Development Review Comments

May 16, 2023
PAM2023-00148
Submission Review Comments
14225 Glen Mill Road – Parallel Hope Schools

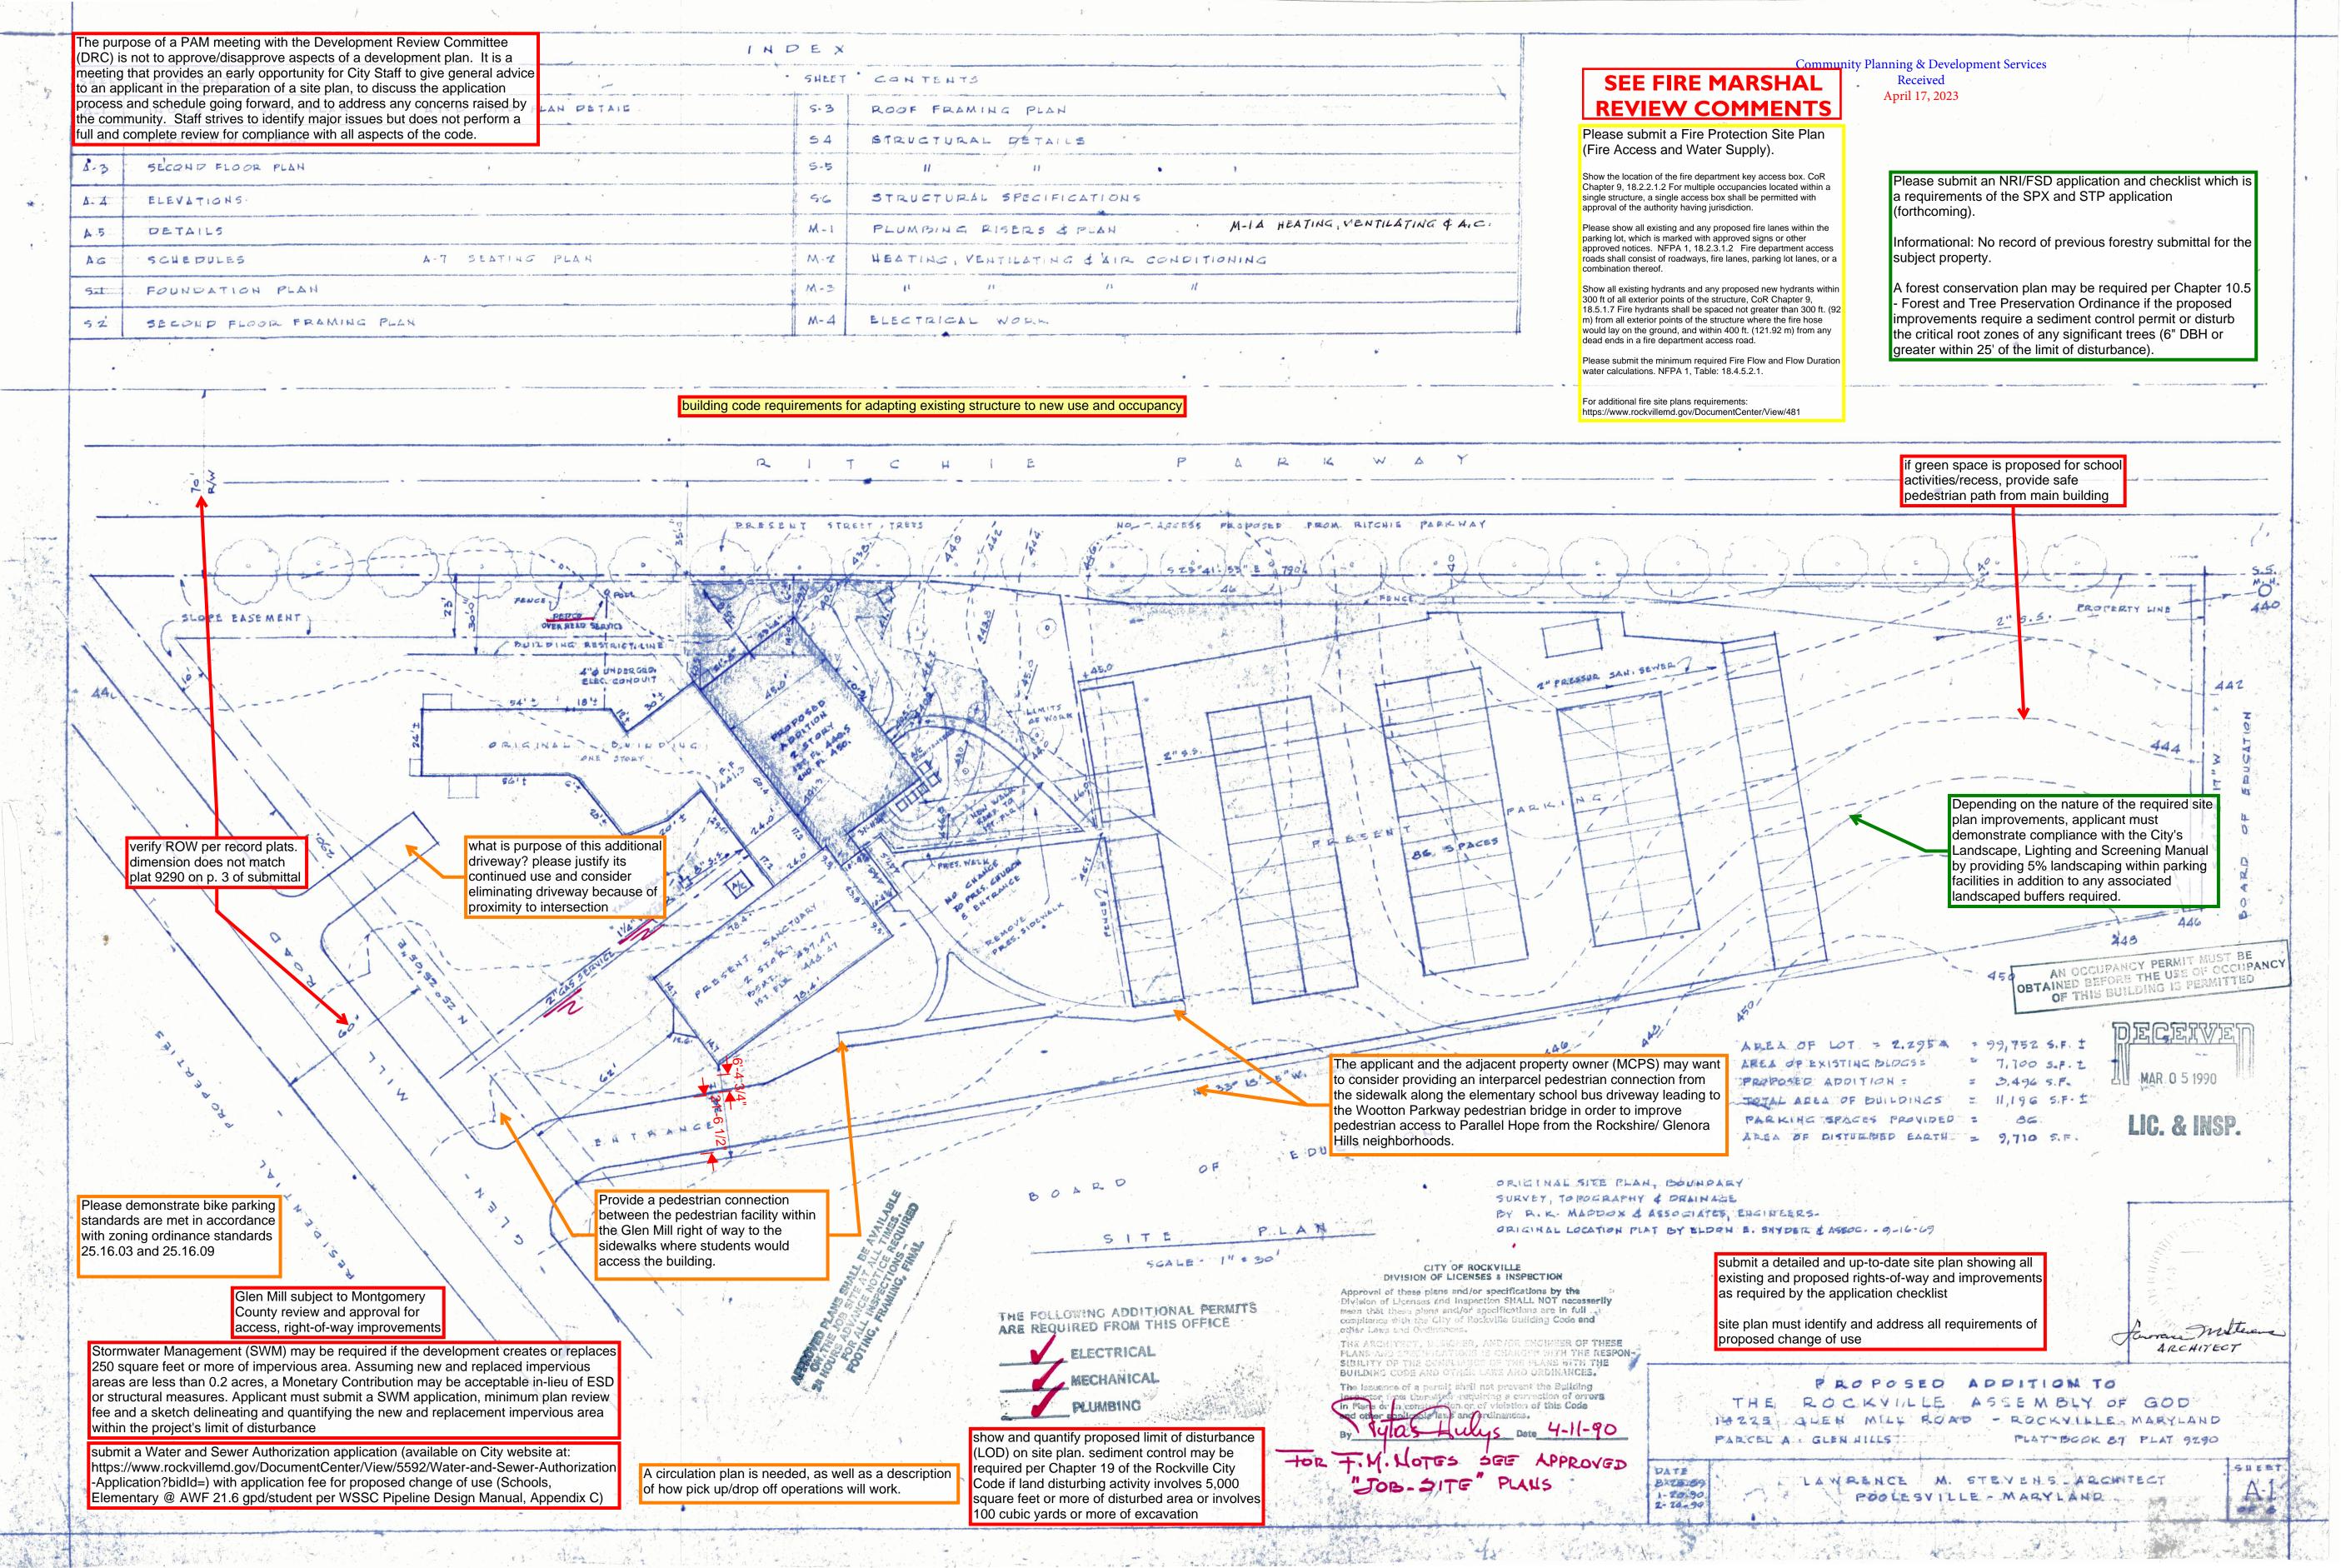
- Are additional access points being considered in addition to the existing one on Glen Mill Road?
- The access to the Lakewood Elementary school is right next to this entrance to a proposed school (church was fine with weekend-only traffic; the school would generate additional weekday traffic)
- 3. Having 2 adjacent unrestricted access points creates multiple conflict points and would not be acceptable (has the developer considered the option to work with Lakewood Elementary to combine both the access points)
- 4. MCDOT would like to review the counts at the intersection of Glen Mill Road and Wootton Parkway (at the TIS stage).
- 5. The County's Bicycle Master Plan recommends a sidepath along their Glen Mill Road street frontage. The applicant should either construct it or pay a fee in lieu. The path should be 10 feet wide minimum. Here's the cross section for their side of the road:

10.5 foot travel lane

6 foot tree buffer

10 foot sidepath (shared use path)

2 foot maintenance buffer.
